**Review of the Technical Aspects  
of the  
Sepon Project Environmental and Social Impact Assessment  
Addendum Volume 2: Main Report Text  
NSR Environmental Consultants Pty Ltd, in association with Earth Systems Lao.  
October 2002**

David M. Chambers, Ph.D.  
CENTER for SCIENCE in PUBLIC PARTICIPATION  
February 6, 2003

ESIA Addendum Figure 7.17 Showing Project Layout of both the Sepon Gold (in gray) and Copper (in color) Projects

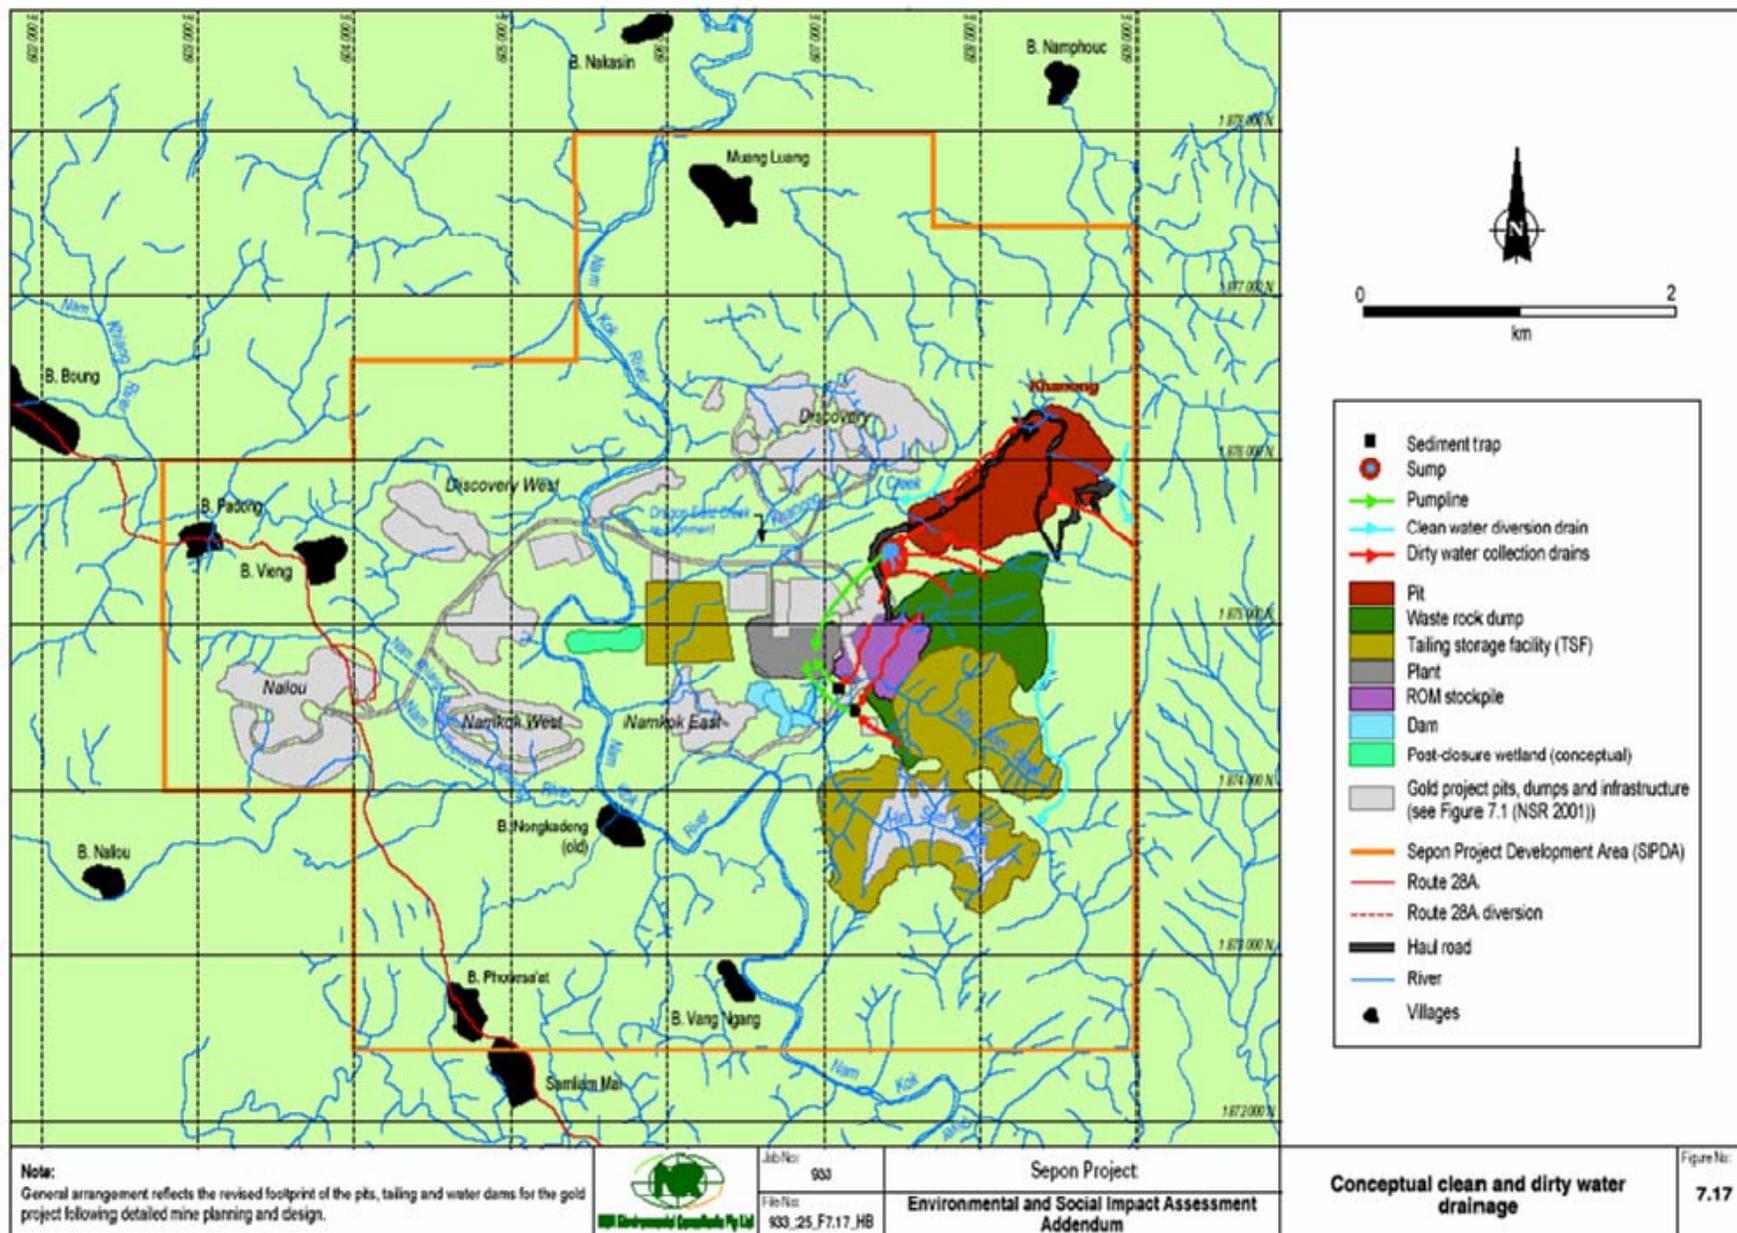
- (1) Pressure Oxidation of the copper concentrate might lead to mercury contamination via airborne emissions. This potential for this contamination needs to be discussed/analyzed.
- (2) The appropriate standard to use for measuring the potential impacts of mercury release to surface and groundwater is the human health standard, not the chronic aquatic standard, which is being applied in the ESIA.

- (3) Acid generation from the waste rock probably poses the greatest long term risk to the environment because of the large volume of this waste, the physical characteristics of the waste which can allow rapid exposure to air and water, and the cover/encapsulation designs which are not as sophisticated (and expensive) as those employed for the tailings. Great care must be taken to establish good pre and post closure monitoring to detect the presence of acid generation, and an adequate financial surety should be retained to provide for collection and treatment of contamination should the effectiveness of the planned closure scheme fail to meet closure objectives.

*Waste Rock Dump Construction (ESIA Addendum Appendix 19 Figure 6.2)*

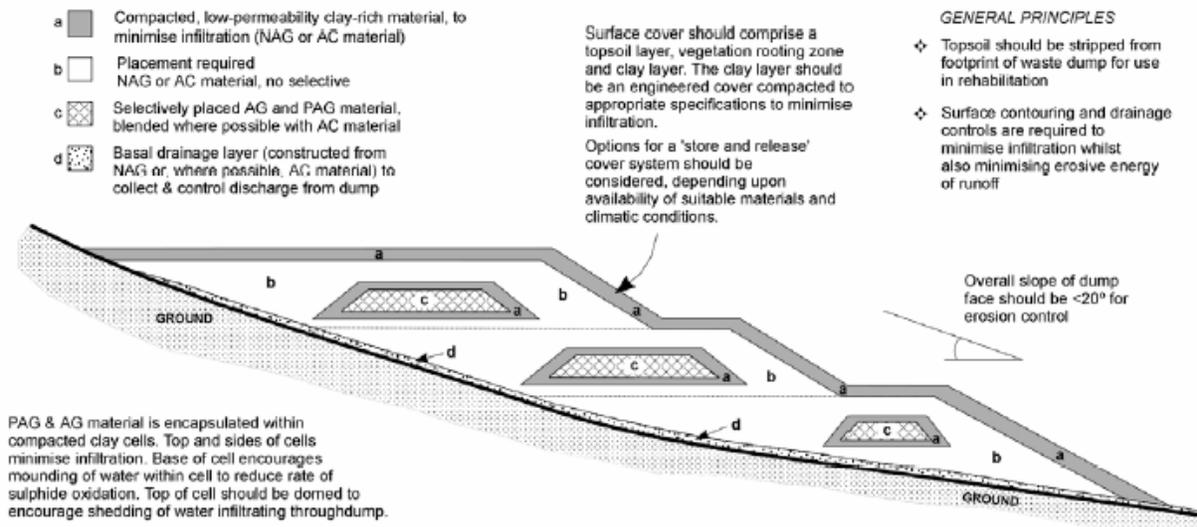
The engineering specifications for the waste dumps covers and drains are still tentative as presented in the ESIA Addendum and supporting Appendices. It would be best to specify a full engineering design so that materials can be put aside for construction, and so financial provisions can be made. This will not preclude changing the design in the future, should better waste storage technology become available, but does insure that the waste will be stored with a design that is acceptable based on the best understanding of waste storage technology available today.

The Option selected in the ESIA appears to be Option 2, Minimisation of Infiltration. While this is potentially the least costly of the options, the consultant in its report in Appendix 19 has cautioned:

“For Option 2, it is expected that there will be a high risk of acid drainage from waste rock dumps containing sulphidic materials.”<sup>10</sup>

Because the risk of acid drainage is great, additional care should be taken not only in designing measures for the waste rock that will inhibit the generation of acid, and the isolation and collection of any contamination that may result, but also appropriate financial measures should be taken to insure that if acid generation and metal contamination is worse than predicted, there are financial resources available to collect and treat that contamination.

**Recommendation:** In order to minimize the flow/transmission of water and oxygen, minimum specifications for thickness, compaction, and permeability of the compacted clay layer should be specified in writing before construction begins, along with applying appropriate quality control measures during construction of the waste rock dumps.

*Proposed Cover for Tailing Impoundments(ESIA Addendum Figure 7.19)*

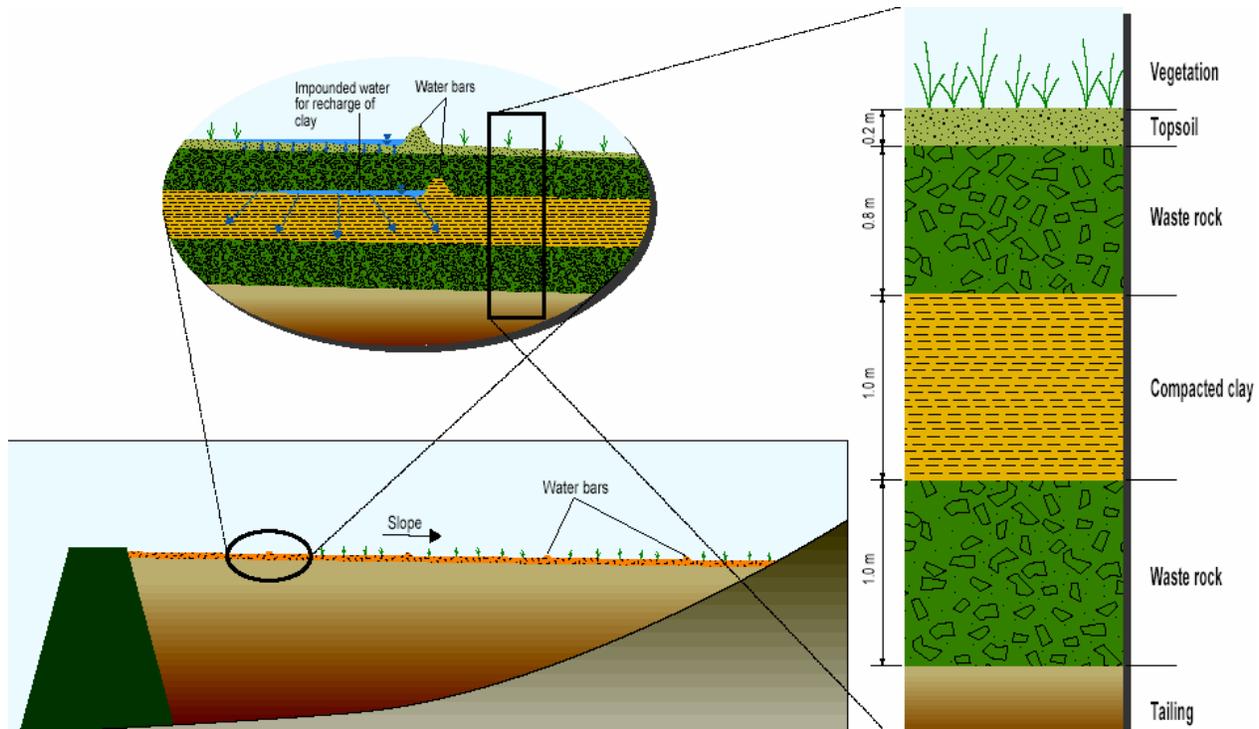
The oxygen barrier covers for the tailings impoundments will have 1 meter of soil/waste rock on top of the 1 meter thick clay layer that is function as the oxygen barrier.

It is important that the clay layer (1) maintain saturation with water; and, (2) not be penetrated by plant roots which would destroy the physical integrity of the barrier.

Plants with roots greater that can penetrate greater than 1 meter in depth are not uncommon. However, care must be taken to identify which local plants/trees are potentially likely to penetrate the clay layer with their roots.

**Recommendation:** A survey by a botanist familiar with the local plant and tree assemblages should specify which plants and trees might constitute a risk to the integrity of the clay layer. A plan to keep these plants and trees from becoming established on the tailings impoundment covers must be incorporated into the long term management plan for all engineered covers, including the rehabilitated tailings impoundments and the mine pit. As with the pit cover, the oxygen diffusion rate for the tailings facilities covers should also be calculated.

Alternatively, the thickness of the waste rock layer between the soil layer and the clay layer can be increased to provide an additional buffer to protect the clay layer.

Figure 4.1 from Appendix 22, Freshwater Impacts – Stage 2, showing the portions of the streams that will be potentially “severely (in red)” and “moderately (in gold) impacted during construction.

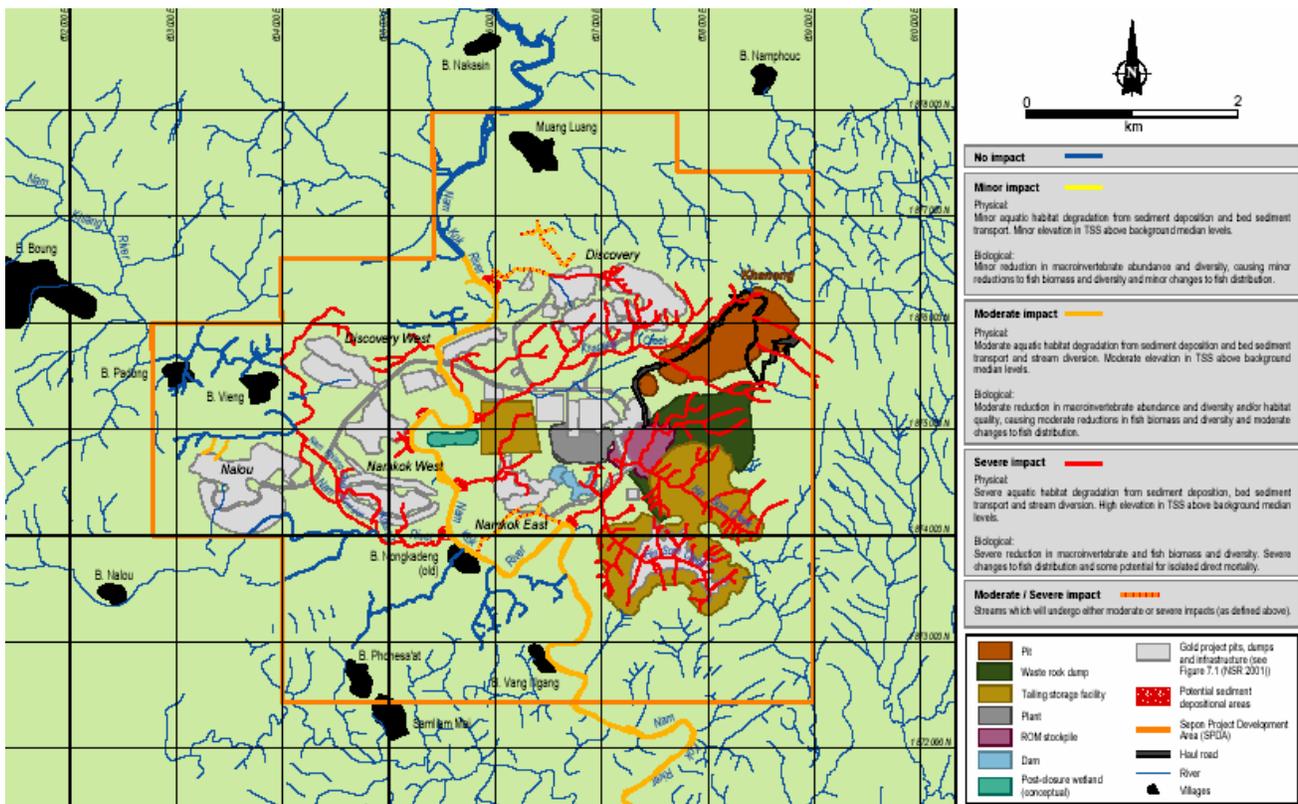
There is already the potential for “serious” impacts to the aquatic ecosystem during the “maximum” year, Year 2 - construction. It is not clear what sort of impact the 17% - 19% withdrawal of water from the river during low flow conditions will have.

The goal should be to avoid “significant” impacts, not just "serious" impacts. Copper startup operations withdrawing 17% -19% of the flow could likely impact aquatic life.

Setting a limit for maximum withdrawal might be appropriate.

**Recommendation:** More discussion of the potential impacts from water withdrawal during copper startup operations during the dry season is warranted in the ESIA. The goal for protecting environmental values in the river should be to prevent any “significant” impacts, not just “severe” impacts.
